[Docket No. FAA-2016-9418; Product Identifier 2016-NE-23-AD; Amendment 39-19167; AD 2018-02-14]

Airworthiness Directives; Honeywell International Inc. Turboprop and Turboshift Engines

ACTION: Final rule.

Figure 1 to Paragraph (h) of this AD. Combustion Chamber Case Assembly

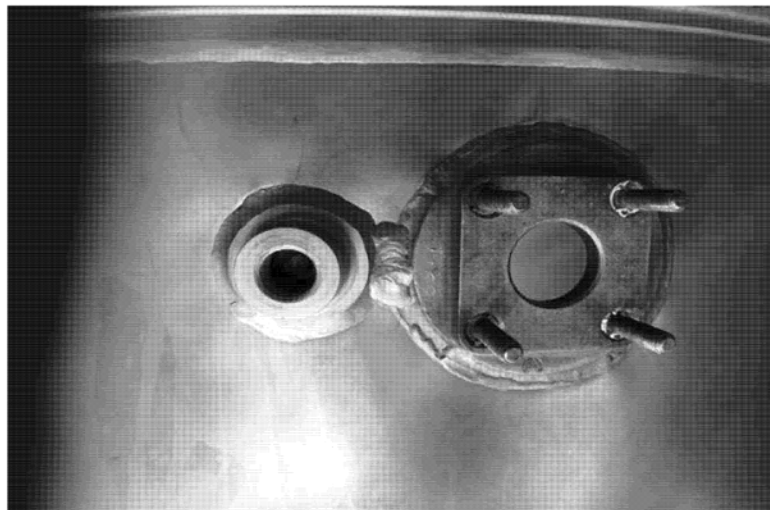
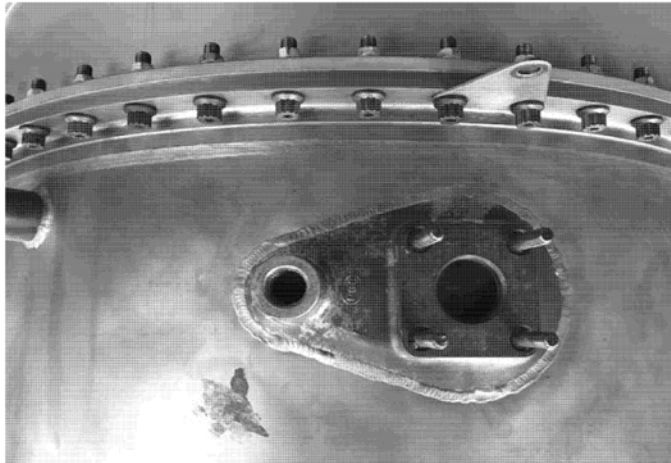
TPE331 model engines modified by STC SE383CH may be defined as the “Super 1” and “Super 2” for the compressor modification of the TPE331-1 and the TPE331-2, -2U, and -2UA engines, respectively. Figures 1 and 2 to paragraph (h) of this AD illustrate the appearance of combustion chamber case assembly, P/N 893973-5, without and with, respectively, the one-piece bleed pad with the P3 boss.

After the effective date of this AD, do not install a combustion chamber case assembly, P/N 869728-1, 869728-3, or 893973-5, in TPE331-3U, -3UW, -5, -5A, -5AB, -5B, -6, and -6A engines or in TPE331-1, -2, and -2UA engines modified by National Flight Services, Inc., STC SE383CH, unless the combustion chamber case assembly has a one-piece bleed pad with P3 boss.
